REMARKS

The claims before the Examiner are directed toward a non-volatile memory device for storing both code and data. While the device is programming or erasing its nonvolatile memory, if a host system sends the device a read request, hardware such as one or more logic circuits in the device signals the host to delay executing the request while the device suspends the programming/erasing. Then the hardware suspends the programming/erasing and signals the host to execute the read request. When all read requests have concluded, the hardware resumes the programming/erasing.

FIGURE 1 (PRIOR ART)

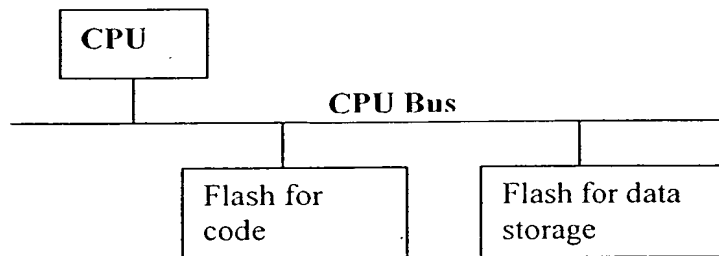
The Examiner has objected to Figure 1 for lacking a legend such as “PRIOR ART” to indicate that only prior art is illustrated. Attached please find a replacement drawing in which both Figure 1 and Figure 2 are labeled as PRIOR ART in red.

FIGURE 3

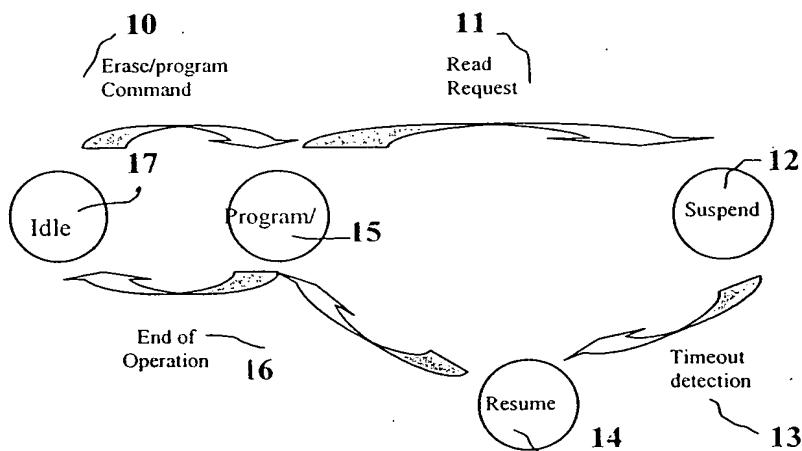
In step vi of claim 14, “entering...into resume operations” has been changed to “exiting...from said suspended mode”. Support for this amendment is found in the specification in Figure 3, in which arrow **13** represents exiting from suspend state **12** to resume state **14**.
